Form 3160-5

1	014	HED SIVIE	<b>અ</b>	I LEVEL LE	
June 1990)	DEPARTME	NT OF THE	INTERIOR	ELM	Budget Bureau No. 1004-0135
	BUREAU OF	LAND MAN	IAGEMENT		Expires: March 31, 1993  5. Lease Designation and Serial No.
				SISTP 20 PY	: sûr 7080213
	SUNDRY NOTICES	S AND REPO	ORTS ON WELLS	/	4 141 1
Do not us	e this form for proposals to d	Irill or to dee	pen or reentry to a $\hat{k}$	different reservoir.	II. N.M.
	Use "APPLICATION FO	OR PERMIT-	" for such proposal	s	
	SUBMI	T IN TRIPLI	CATE		7 If Unit or CA, Agreement Designation
1 Type of Well	1				RINCON UNIT
Oil X Gas Other					8. Well Name and No.
2 Name of Ope					227
UNION OIL	COMPANY OF CALIFORNIA, DBA	UNOCAL.			9. API Well No.

3. Address and Telephone No.			30-039-21399		
3300 NORTH BUTLER, SUITE 200, FARMINGTON, NM 87401 (505) 326-7600			10. Field and Pool, or Exploratory Area		
Location of Well (Footage, Sec., T., R., M., or Survey Description)			BASIN DAKOTA

11. County or Parish, State
1850' FSL	& 2080' FEL				,
SEC. 28,	T27N, R7W				RIO ARRIBA, NM
: C	HECK APPROPRIATE BOX	(s) TO INDIC	CATE NATURE OF	NOTICE, REPOR	T, OR OTHER DATA
T	YPE OF SUBMISSION			TYPE OF ACTION	
	Notice of Intent D) E G	VEN	Abandonment		Change of Plans

### PACKER INSTALLATION PLAN

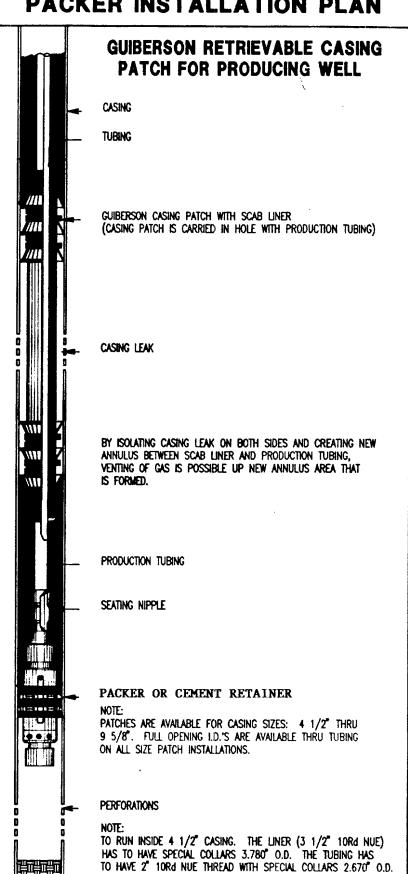
Due to current market conditions and gas price, testing has indicated marginal economics associated with squeeze cement casing repair because of the high cost to adequately and effectively seal off a casing leak. However, a more effective and economical casing leak seal can be obtained utilizing the Guiberson Retrievable Casing Patch. A schematic of this type sustem is attached.

The system utilizes two cup type packers with a scab liner between the sealing packers. The casing leak is isolated from above and below, and continuity of the casing annulus is maintained by creating a new annulus between the 3-2" scab liner and the 2-3/8" tubing. This annulus in conjunction with the packer allows for casing pressure monitoring to insure the integrity of the casing seal from above and below the casing patch.

Attached is a wellbore schematic of the current status of the well and a proposed schematic following installation of the casing patch.

The subject approval is temporary (until August 1, 1993). You are required to Conduct and submit results of pressure tests every six months to insure casing in tegraty. You are also required to submit your plans to permently repair the casing by the above date.
